EDWIN I. HATCH NUCLEAR PLANT UNIT 1

AMENDMENT TO FACILITY OPERATING LICENSE

Amendment No. 18
License No. DPR-57

ATTACHMENT TO LICENSE AMENDMENT NO. 18

FIGURE 6.2-1
MANAGERIAL ORGANIZATION

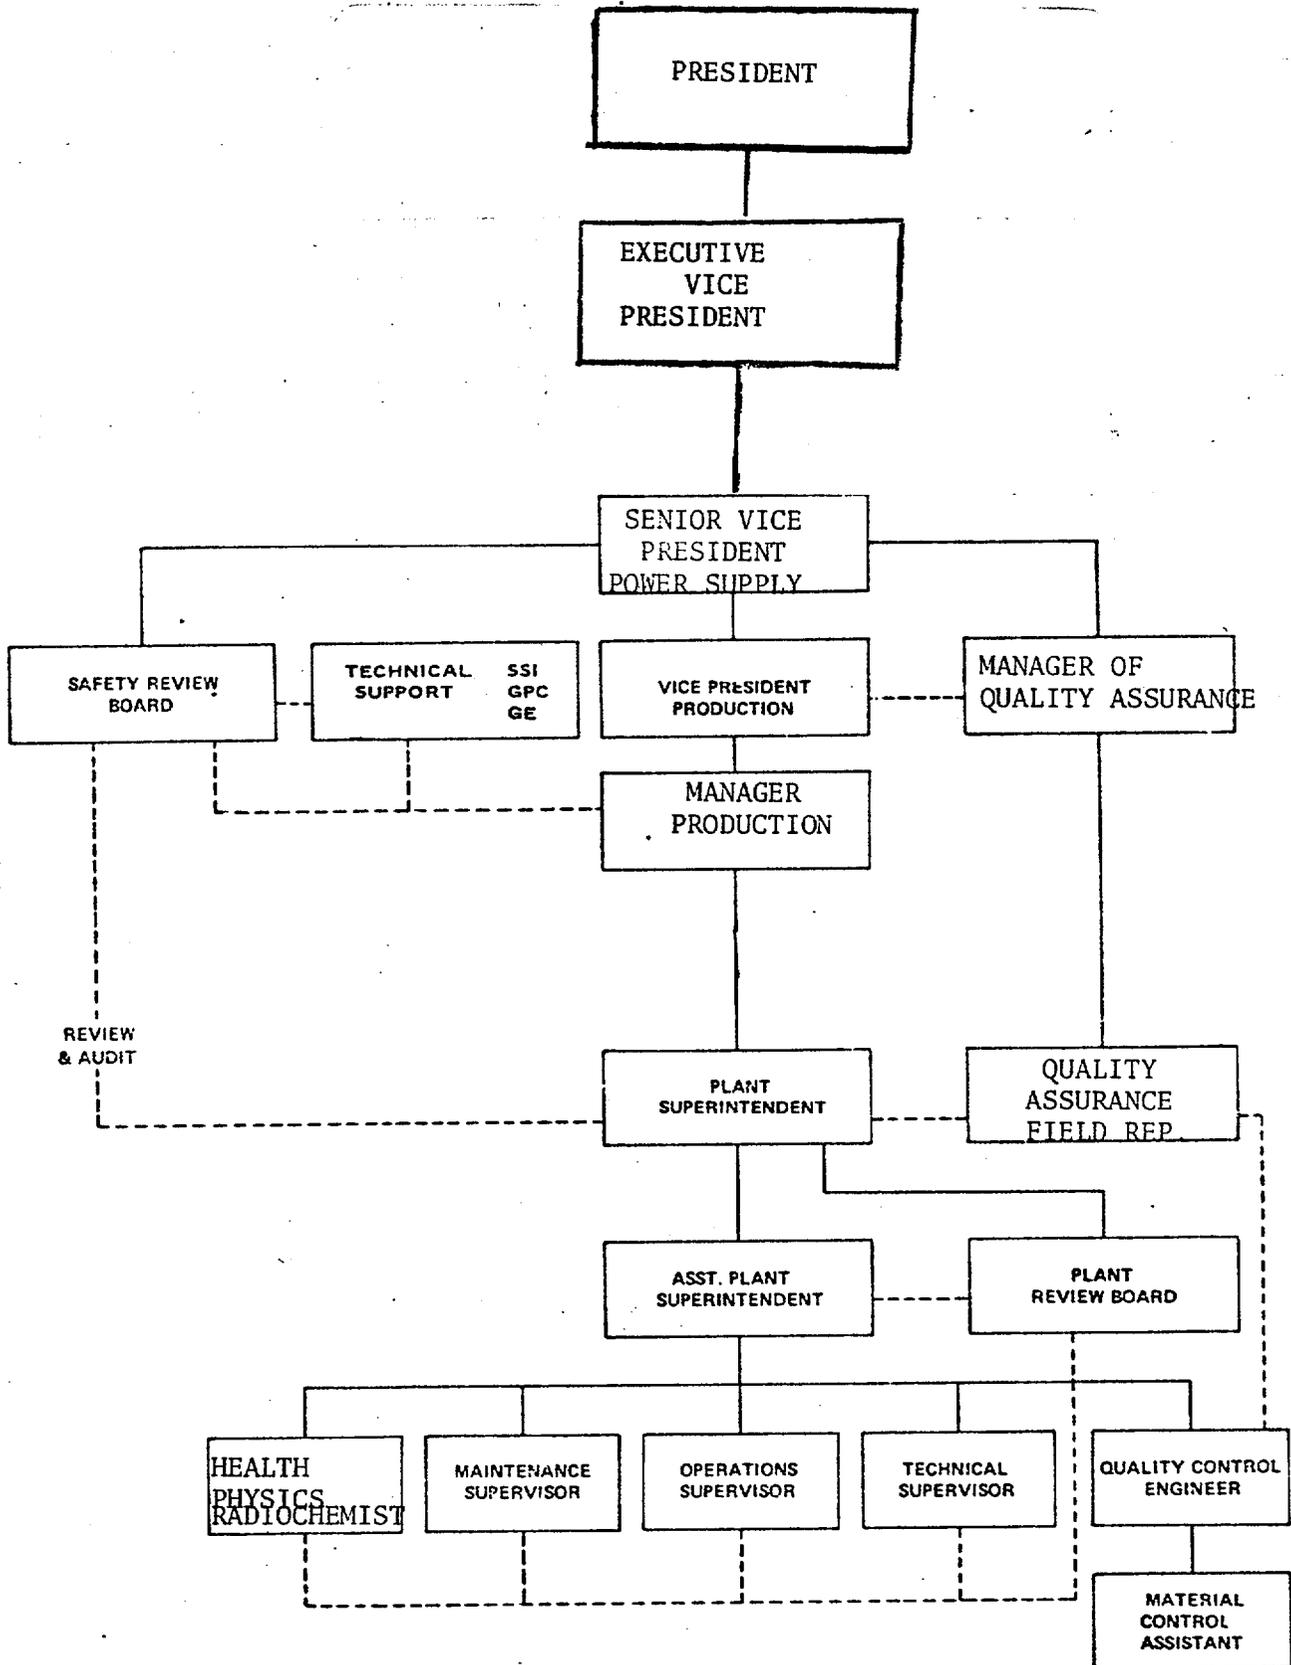
6.2.1 The offsite organization for plant management and technical support is shown in relation to plant supervision on Figure 6.2-1.

FIGURE 6.2-2

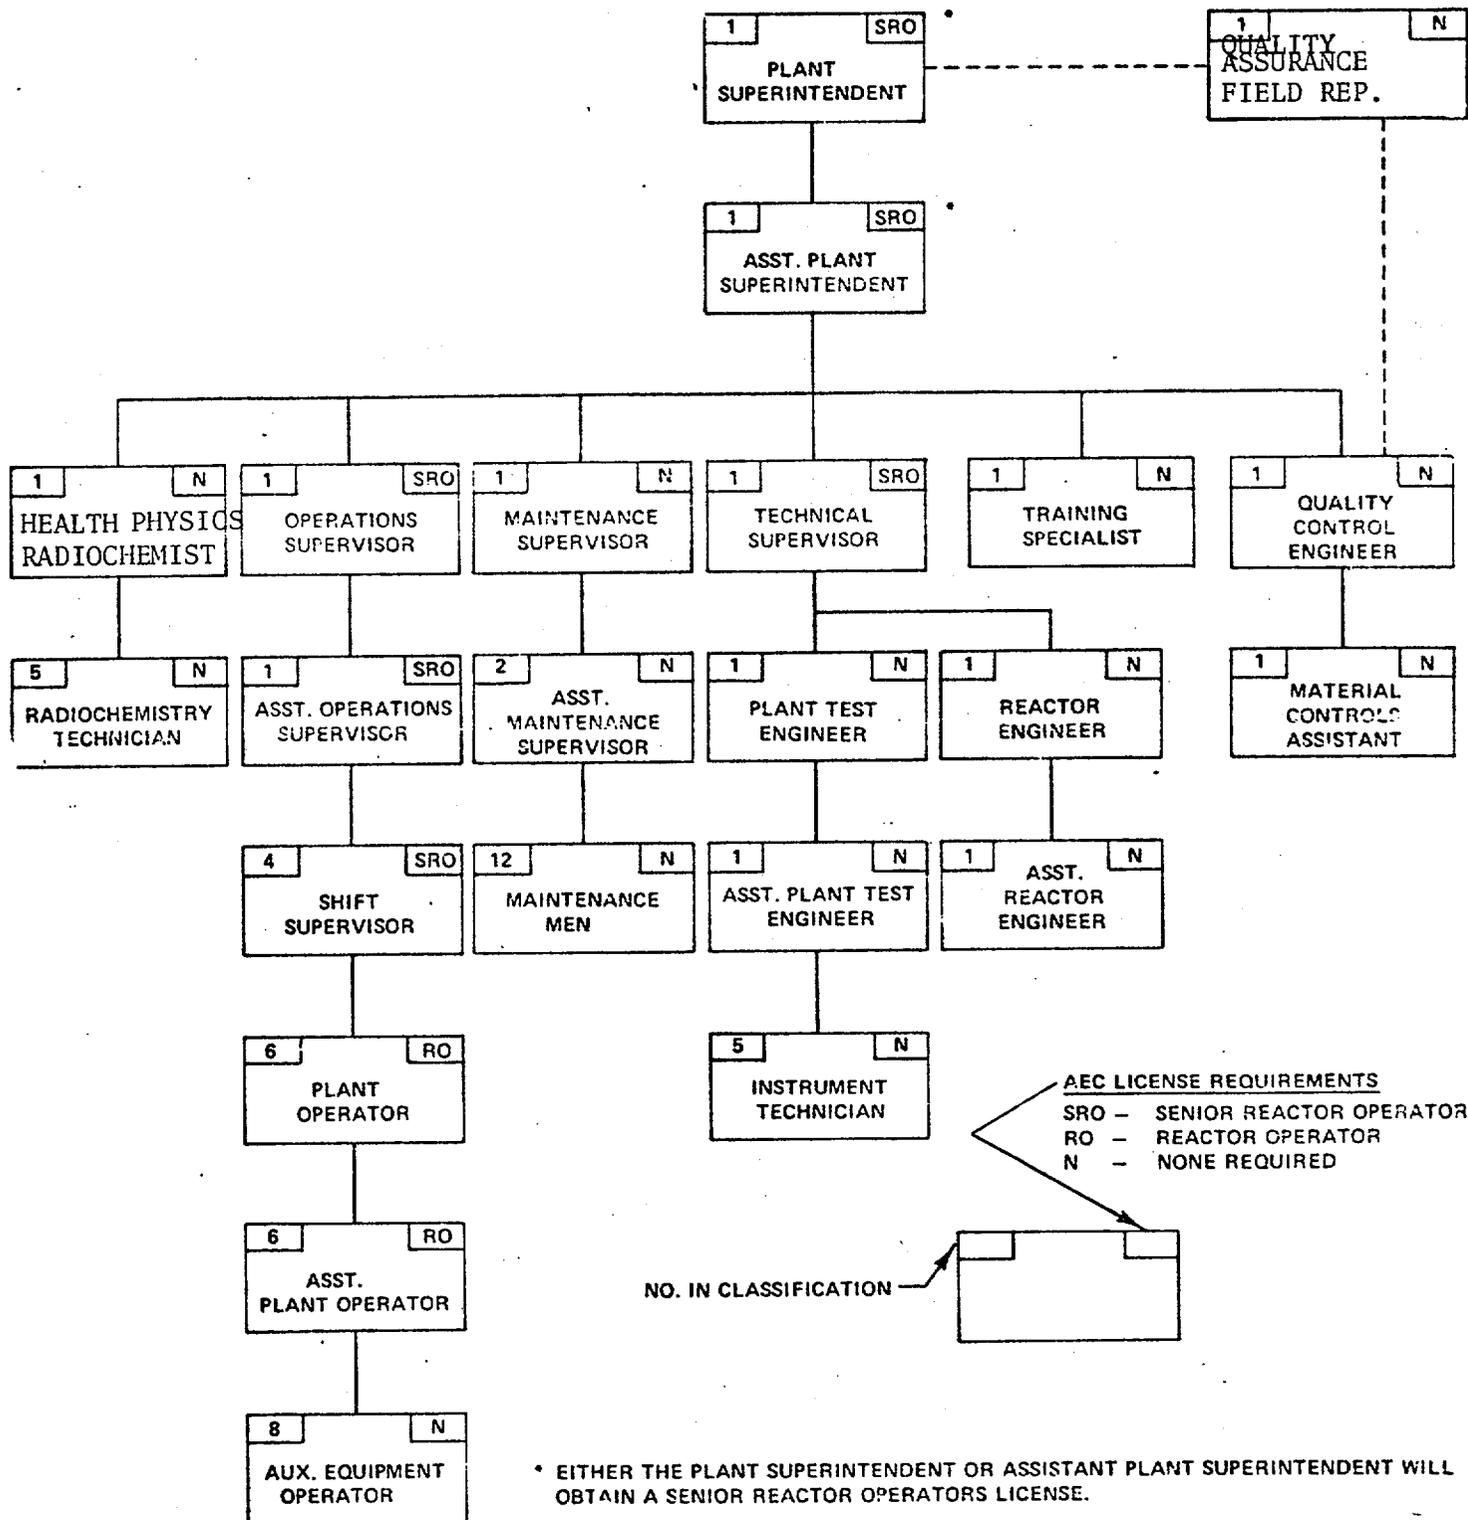
6.2.2 The plant organization shall be as shown on Figure 6.2-2, and:
